# CONSERVATION COMMISSION AGENDA

Date: April 6, 2021

126 Arnold Road

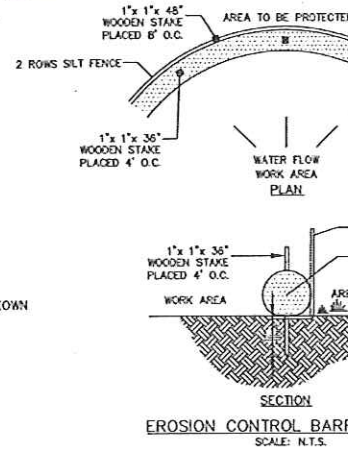
- Staff reviewed the wetland report and requested that the wetland consultant review the site again as the assessment was conducted in Dec. 2021.
  - Areas observed at site visit with water flow and saturation, which were not noted in report. Off-site wetlands which project BZ onto site need to be flagged.

- Staff recommend that the plan is revised to reflect the limit of work (LOW) discussed for agricultural uses and a separate LOW areas of selective tree removal as noted on site. Staff also recommend that this is done after the wetlands are reviewed again. Additional detail on the approximate areas for hayfield, trees and vines should be disclosed as part of the review. If meadow is to be located along the perimeter, staff recommend a mowing restriction be applied in the wildlife habitat.

- Staff recommend that additional buffer zone is provided adjacent to resource areas especially to the C Series wetland. The vegetative buffer shouldn't interfere with shading the site as it is to the north. The site slopes to this wetland and all wetlands and additional buffer should be provided. If the full area is not required for agricultural uses, staff would also recommend that RA impacts are avoided. Alternatives to full site conversion should be explored.

- The project will require a SWPPP with the EPA.
  - The clearing and grubbing should be phased to minimize areas open at one time. A plan shall be developed which outlines this to include additional erosion controls beyond what is shown on the plan.

- Herbicide, fertilizer and pesticide use which can be associated with agriculture is a concern.
- Staff Recommendations: Staff recommend that the board require additional information in regards to wetland delineation as discussed and plan revisions. Continue the public hearing to allow for additional site recon by wetland consultant and for plan revisions. Continue to the next meeting May 4, 2021. If applicant does not grant continuance, staff would have to recommend that the project be denied for lack of information and failure to meet performance standards.

122 Main Street

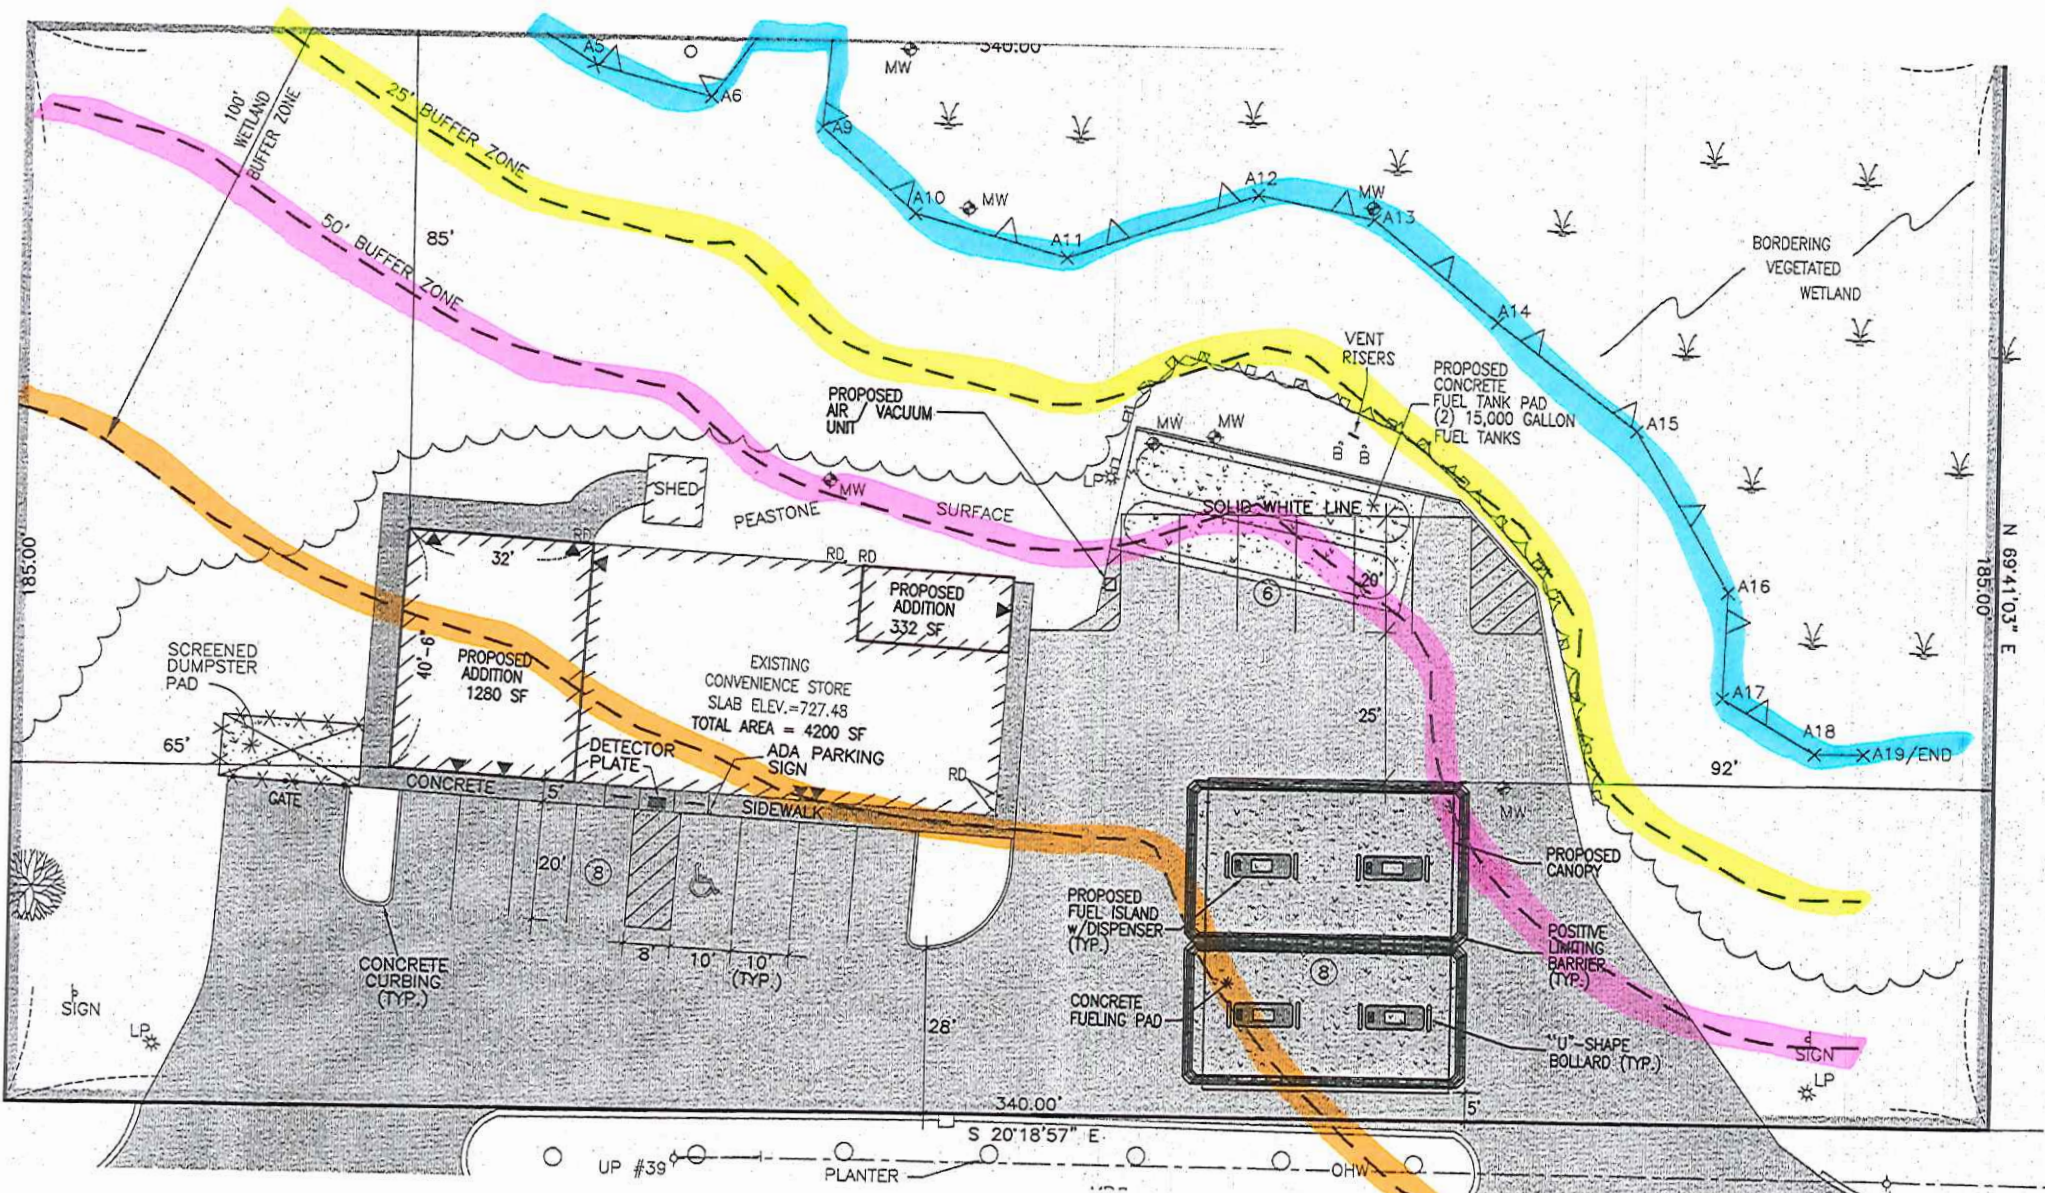
- Revised plans and memo received on April 1, 2021. Some measures included to manage runoff on site. Roof runoff collection proposed and a small stormwater basin. Staff appreciates the inclusions however this is a LUHPL and the stormwater runoff from the parking lot is a priority to be treated and managed.

- Had the tanks not been installed at the rear of the parking lot, this area could have been used for underground stormwater management. Can the tanks be removed and this area be utilized?

- The site does slope to the southwest and will be re-graded as part of the project. Staff would recommend that the northern part of the parking lot be graded to the north and/or catch basins are installed to collect stormwater and direct it to that area. An underground or an above ground system could be installed in the unused portion of the site. Deep sump catch basins and oil grit separators should be incorporated to treat LUHPP stormwater.

- Staff recommend that a site visit is scheduled with the project engineer to review stormwater flow and options to manage and treat parking lot runoff.

- Staff also recommend that alternative options are explored to treat and manage parking lot stormwater.
    - DEP's comments are addressed and stormwater checklist and analysis revised accordingly.

# 57 Caron Road

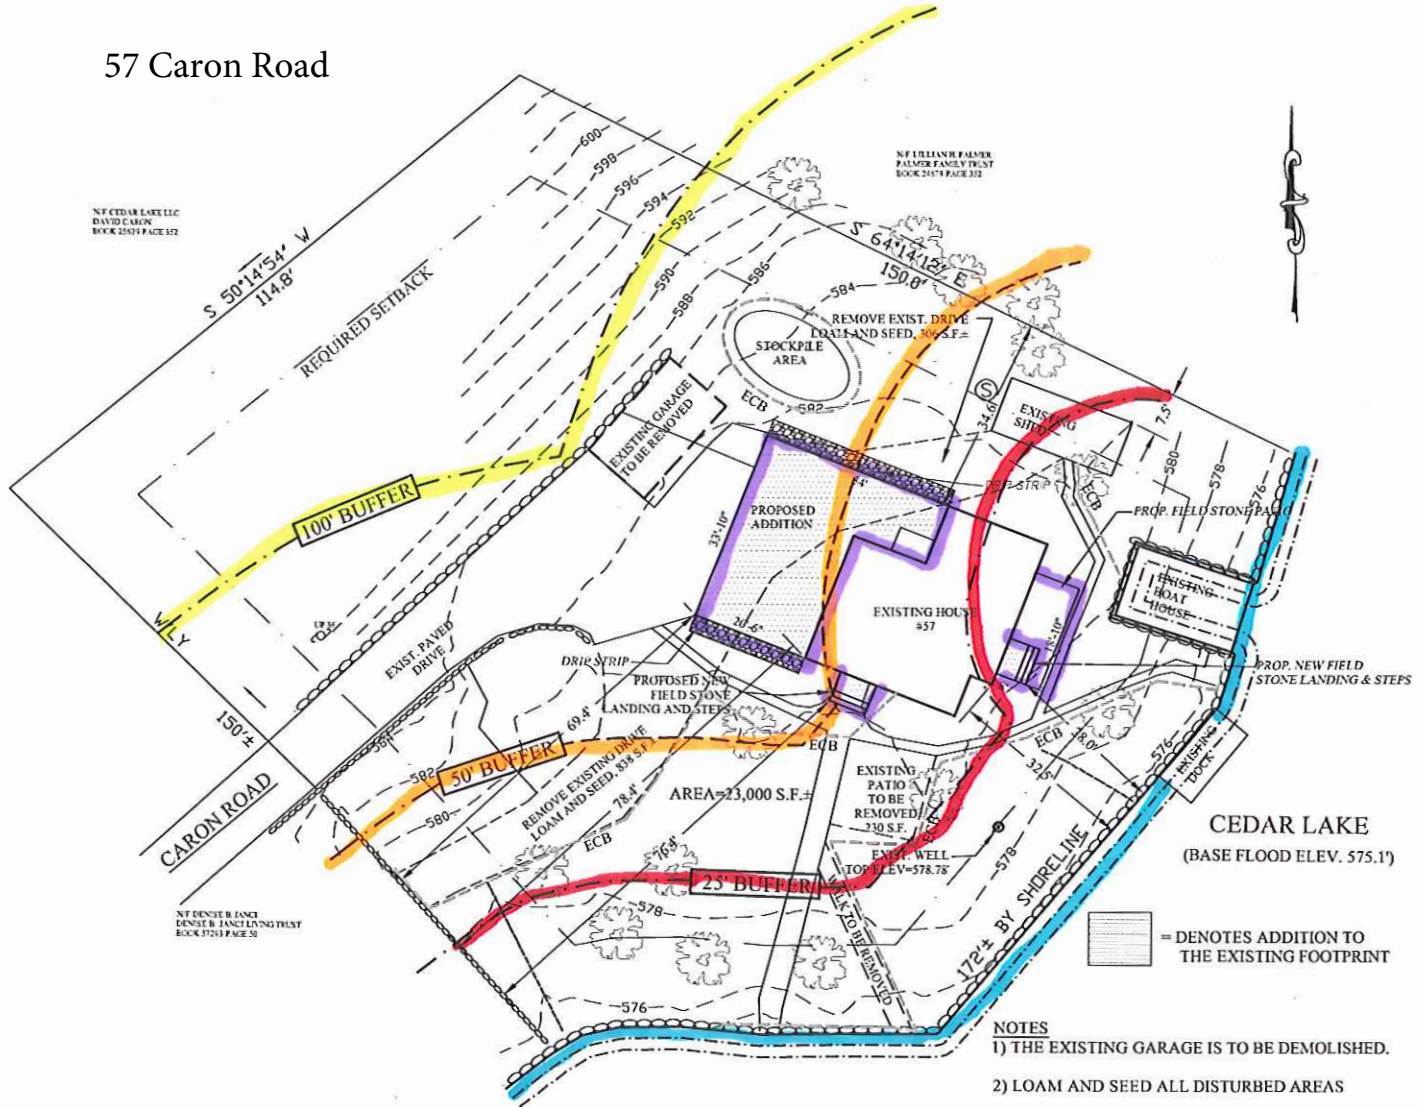
- No work is proposed within resource area. Buffer zone only.
- Portion of the house addition will occur within the 50 ft no new structures however majority will be located outside of this area. Addition will include drip strips for roof runoff.
- Project will remove impervious surfaces within 50 ft of the lake to include the concrete drainage swales. Areas will be loamed and seeded. New field stone steps and pervious patio proposed within 25 ft no disturb, however all work is within existing lawn.
- No trees are proposed to be removed as part of this project.
- Project will result in an improvement over the existing conditions.
- Town Planner comments-The lot is non-conforming and this project will require a Determination from the ZBA. I have been in contact with the engineer to discuss this. I expect an application will be filed soon.

- Staff Recommendations: Continue the public hearing as a DEP File # has not been issued to the next meeting: May 4, 2021. When appropriate, staff would recommend approval of the project with standard special conditions and a condition for the landscape plan to be submitted to the SCC when completed. Recommend native plantings and shade tolerant ground cover or shade tolerant lawn due to shade.
